PD Modification Application: MM 24-1141

Hillsborough
County Florida

Development Services Department

9.0 FULL TRANSPORTATION REPORT (see following pages)**AGENCY REVIEW COMMENT SHEET**

2.5.1 Proposed Site Plan (partial provided below for size and orientation purposes. See Section 8.2 for full site plan)

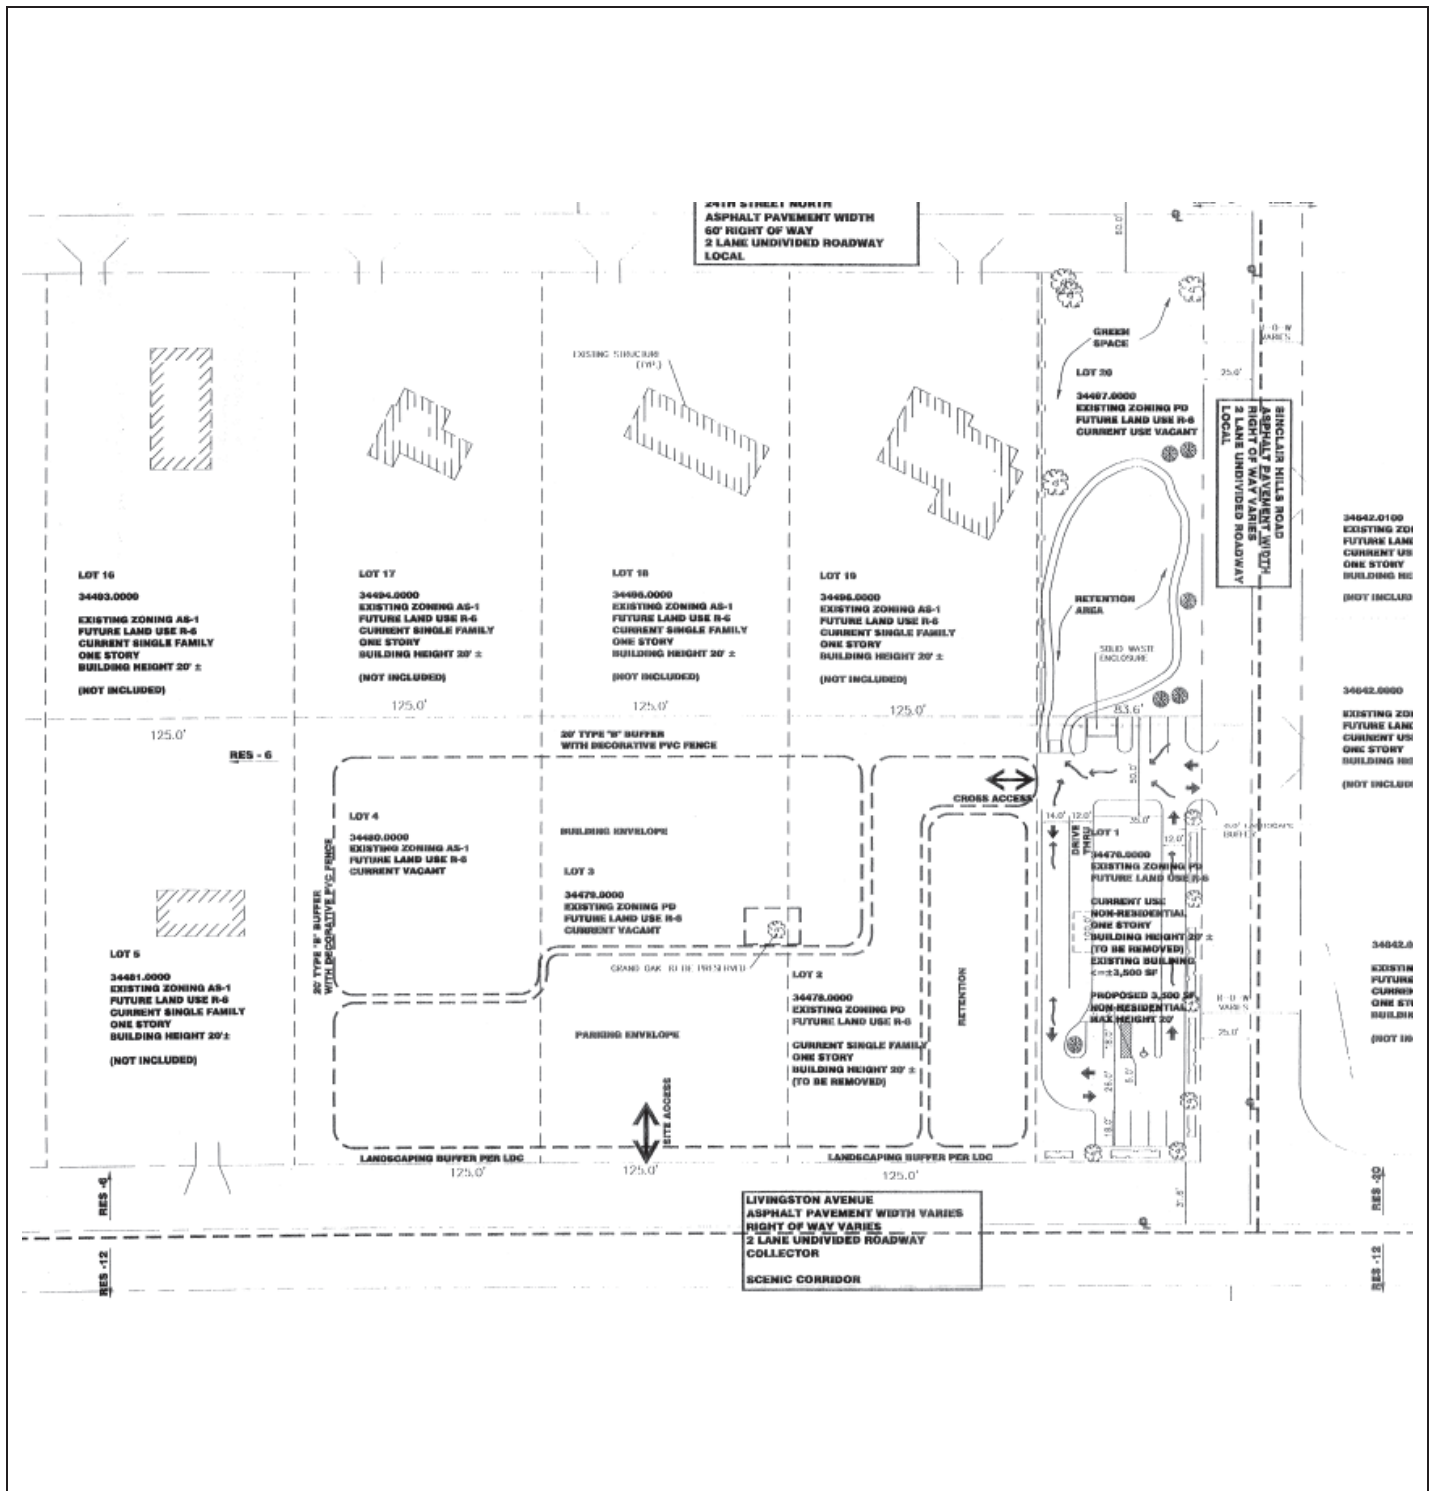
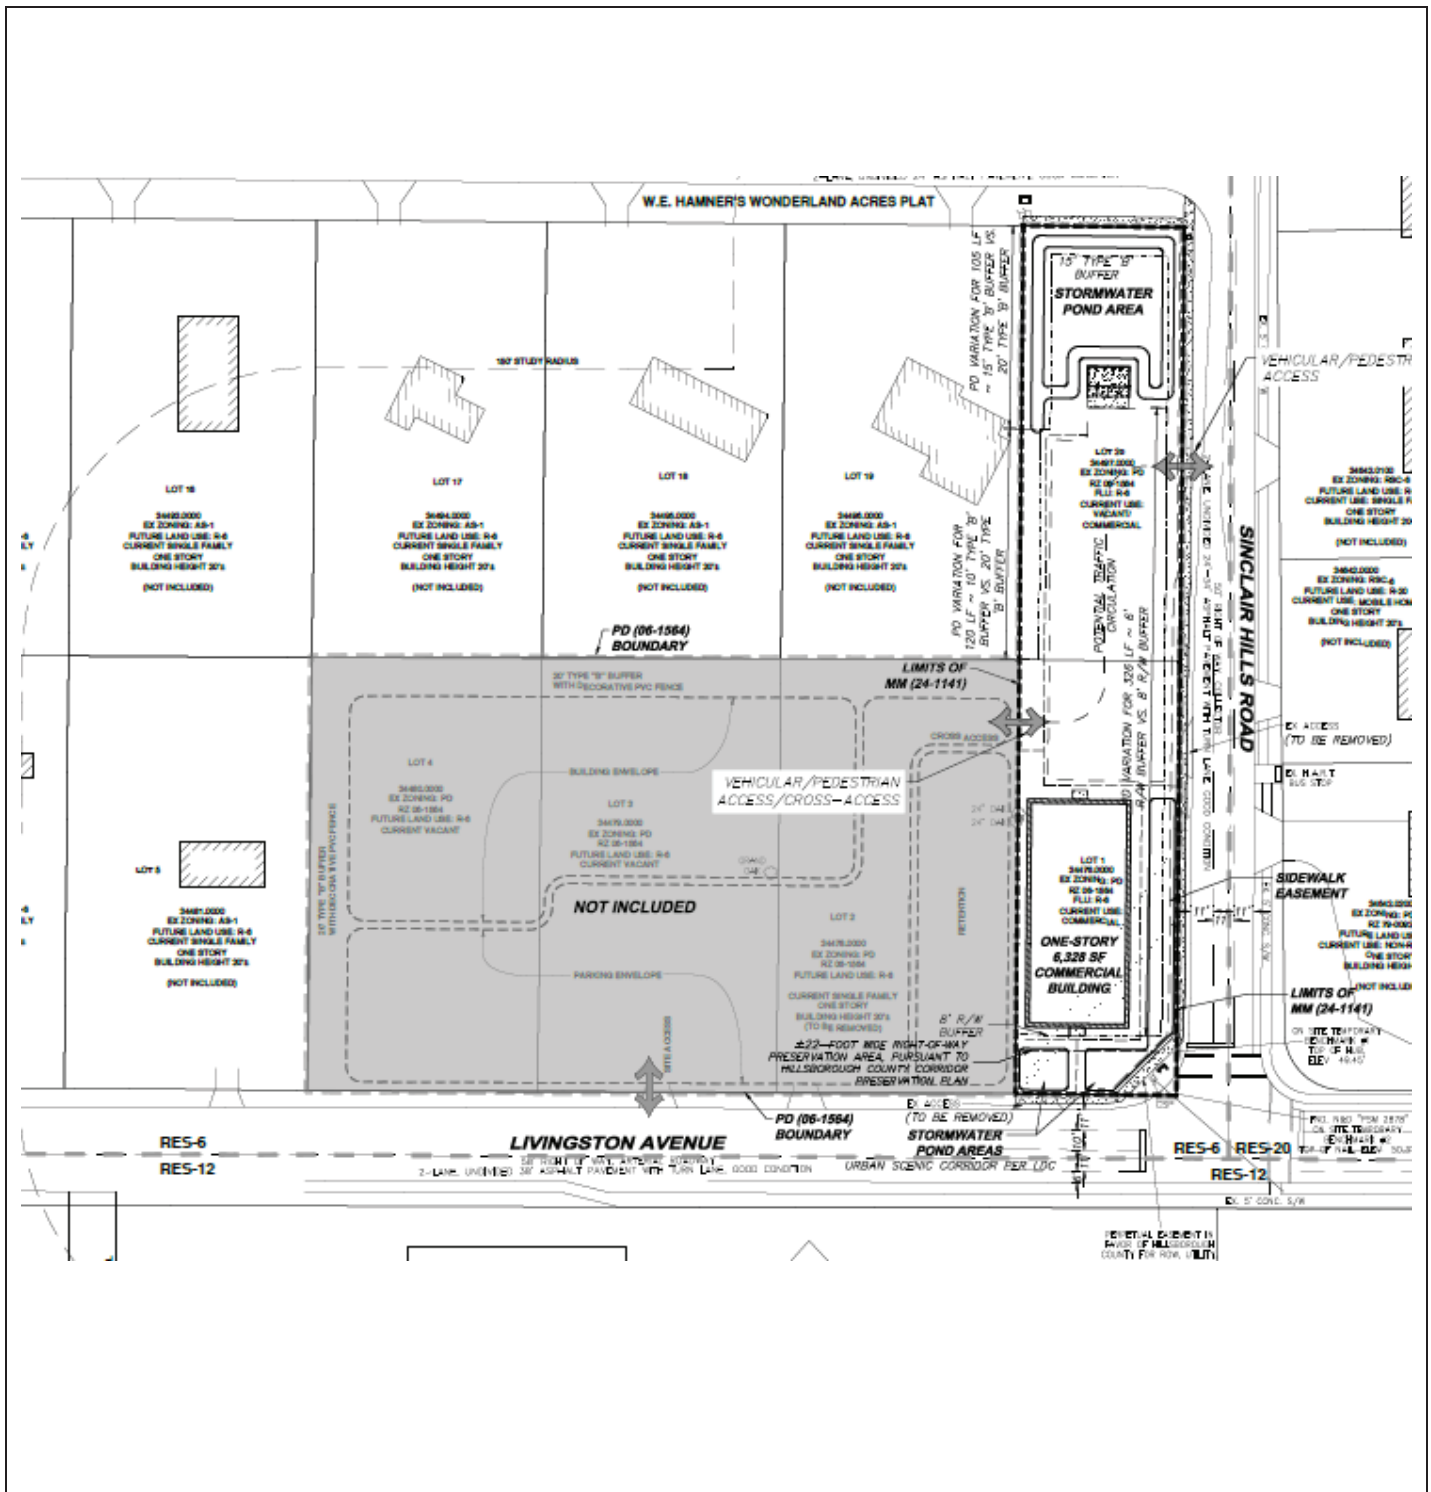
The proposed modification in option 1 would allow 2 food trucks within close proximity to residential. In addition, the applicant has requested a variation that would reduce the 20-foot-wide required buffer next to a food truck to the west to a 5-foot-wide buffer and a 15-foot-wide buffer. These proposed reduced buffers are directly adjacent to a single-family residence zoned AS-1 to the south. The variation requested in option 2 also reduces the 20-foot-wide required buffer to the south residential to a 10-foot-wide buffer and 15-foot-wide buffer. This would not provide adequate buffering of possible noise and disruptions from the business to residential.

Staff opposes these PD variation requests, as they would not provide sufficient buffering to protect residential areas from potential noise and disruptions caused by the commercial activities.

8.2.1 Proposed Site Plan (Full)

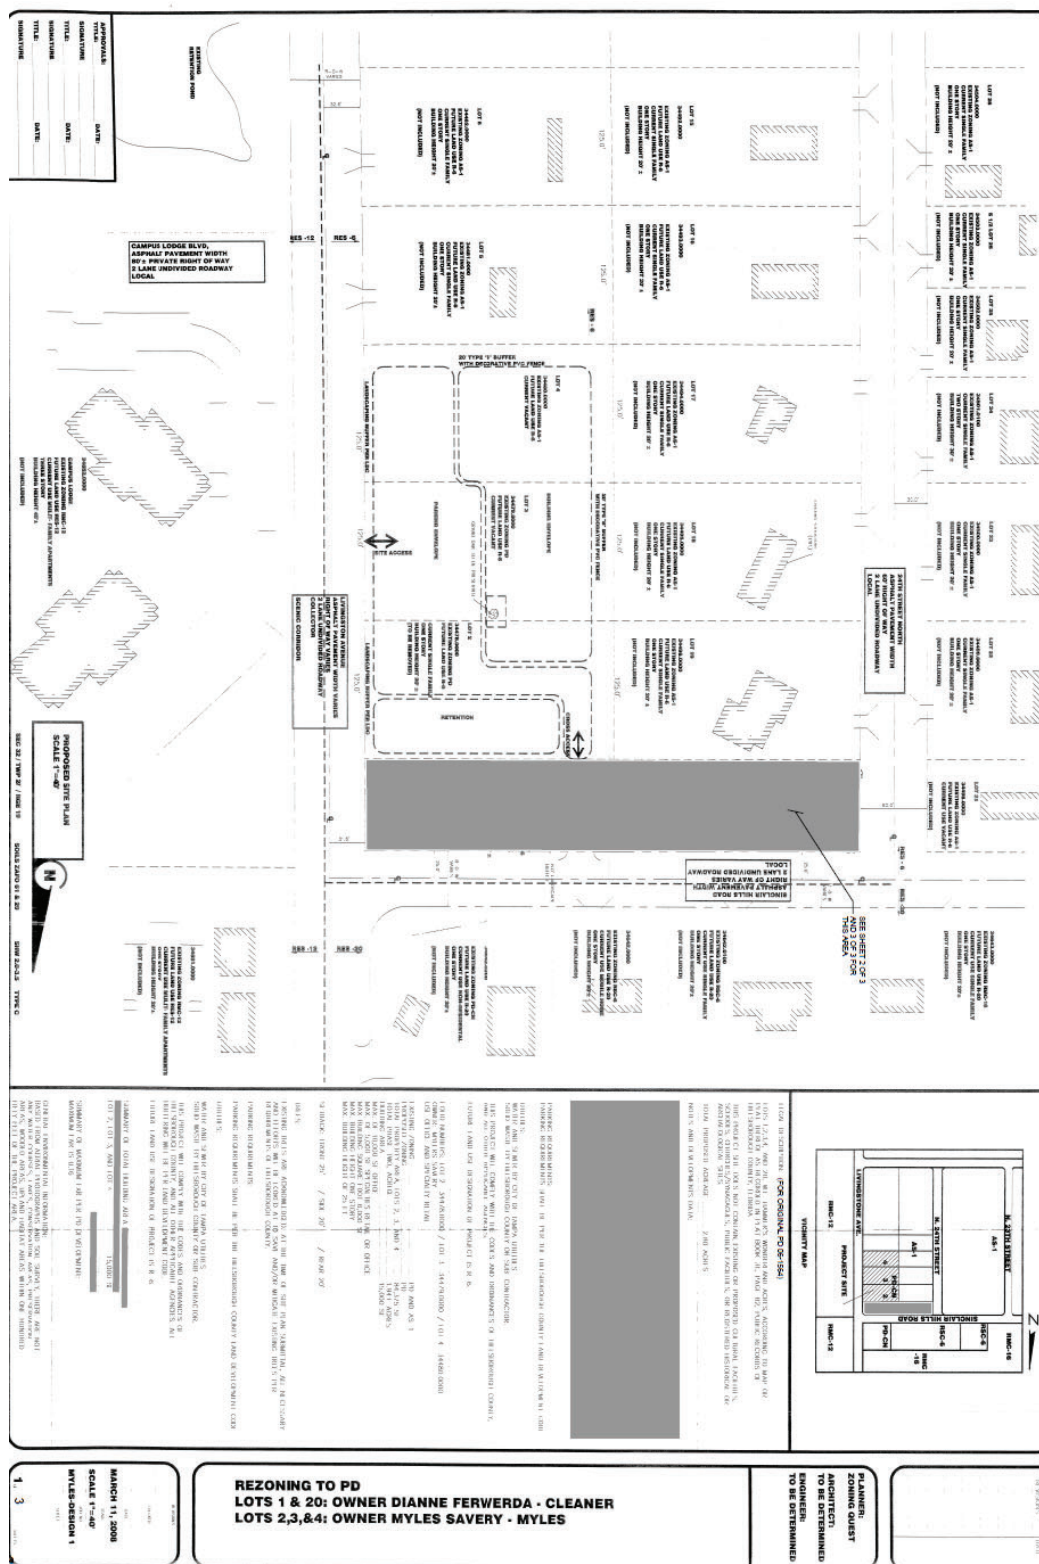
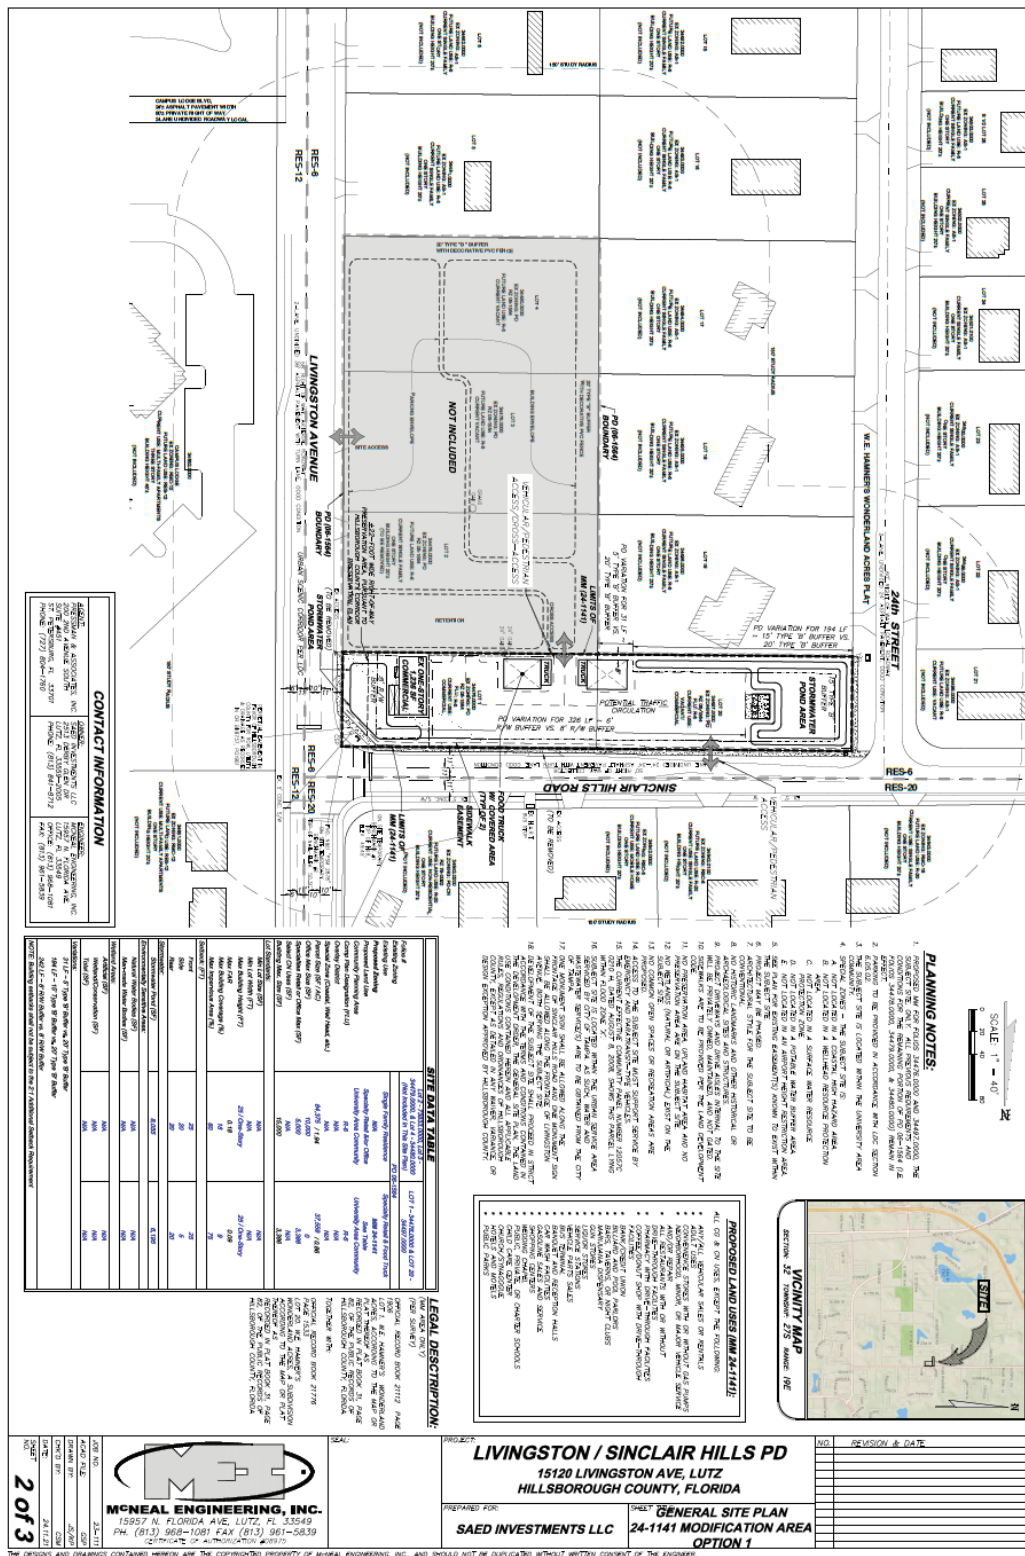
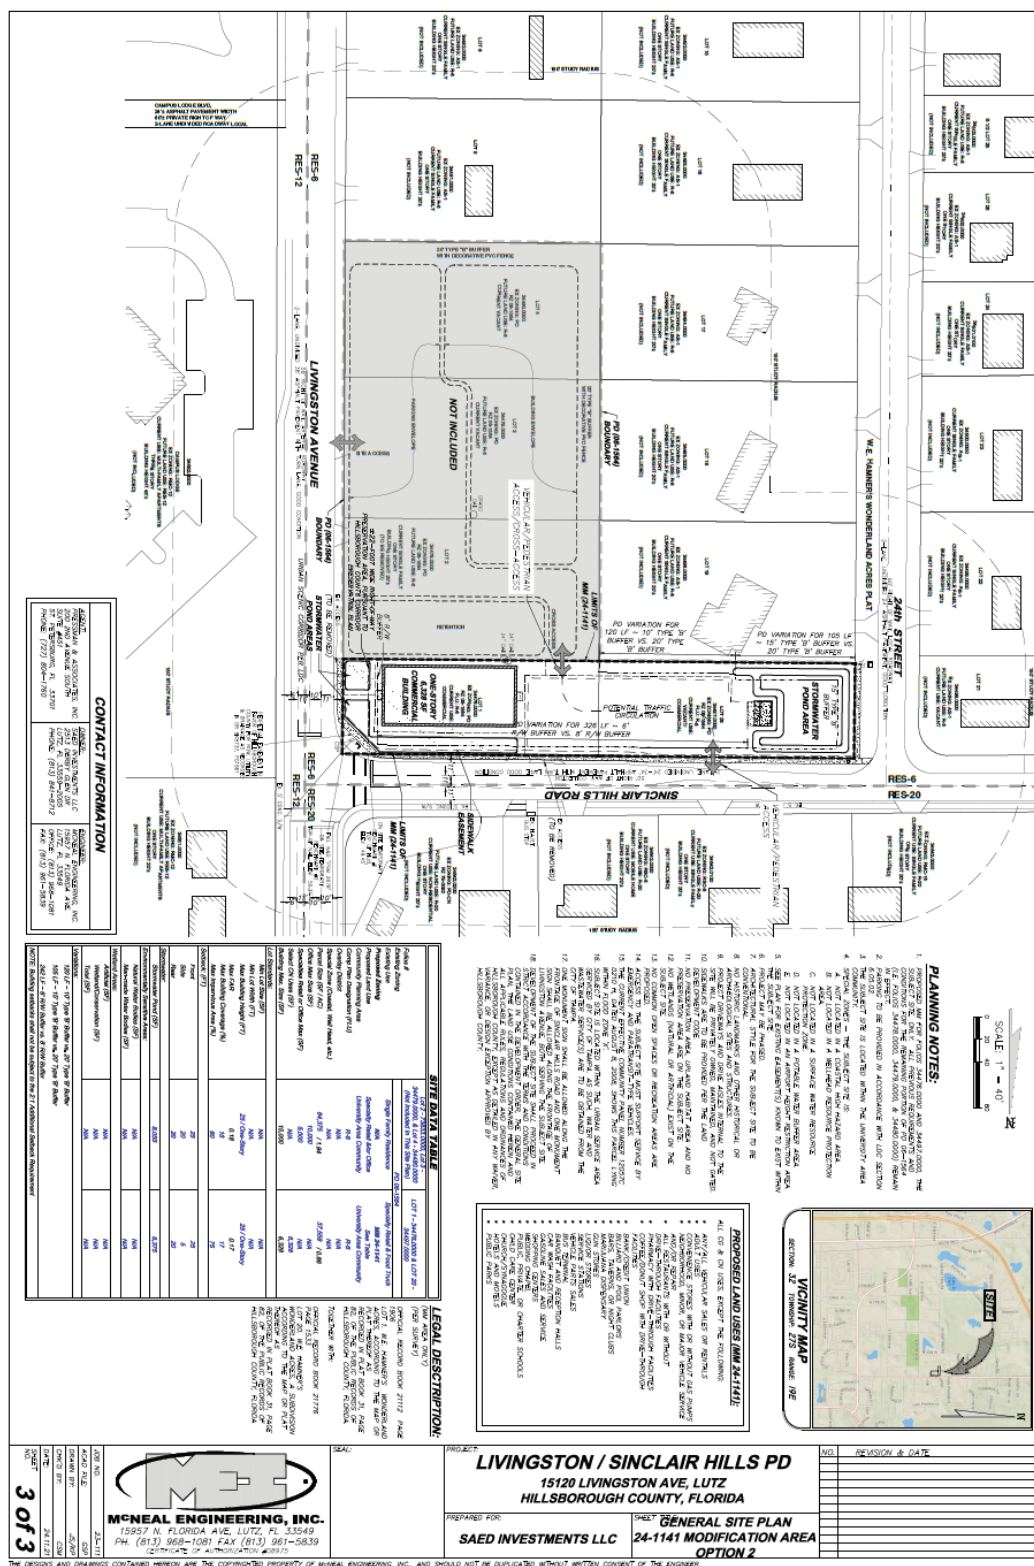
- Prior to PD Site Plan Certification, the developer shall revise the PD site plan to:
 - On Sheets 2 of 3 and 3 of 3, correct the right-of-way preservation label and linework to reflect the requirement that 26 feet of right-of-way be preserved.
